Addendum 23 : Regulation No. 24 to be annexed to the Agreement

Amendment 1

UNIFORM PROVISIONS CONCERNING THE APPROVAL OF VEHICLES EQUIPPED WITH DIESEL ENGINES WITH REGARD TO THE EMISSION OF POLLUTANTS BY THE ENGINE

Model A

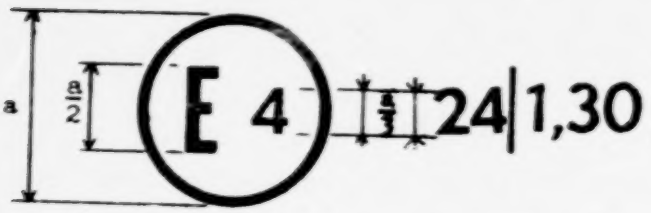
Replace Annex 3 by the following:

"Annex 3

ARRANGEMENTS OF APPROVAL MARKS

a = 8 mm min.

The above approval mark affixed to a vehicle shows that the vehicle type concerned has, with regard to the emission of pollutants by the engine, been approved in the Netherlands (E 4) pursuant to Regulation No. 24.
